Memorandum

Subject: Responses to Comments for the Bear Street Residential Project in Costa Mesa, California

CMSD SEWER ACCESS EXHIBIT
3150 BEAR STREET
COSTA MESA, CALIFORNIA

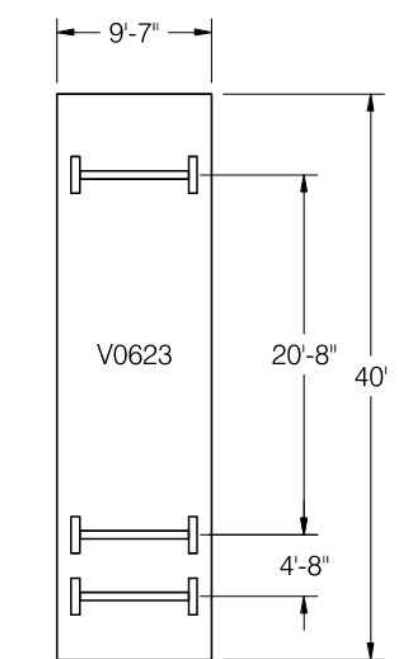
On-Site Delivery Access -The residential design lacks clarity on how delivery and service vehicles (e.g., moving trucks, package vans, utility trucks) will circulate and access units, particularly in a high-density townhome setting. Recommend ensuring:

- Adequate turning radii for delivery trucks.
- Temporary curb loading zones that do not block travel lanes or pedestrian access.
- Shared delivery package lockers or designated delivery zones to reduce repeated vehicle idling and circulation.

A truck turn analysis and exhibit (see Attachment D) was prepared specifically for Costa Mesa Sanitary District sewer utility truck access to and within the site. Furthermore, the proposed project has been designed to allow for adequate fire truck turning radii. This would also apply to delivery trucks visiting the project site. Private drives A through F would provide adequate width for truck access. Furthermore, there are four utility access road turnouts within the site. Mailboxes are located along private drive A and private drive F.
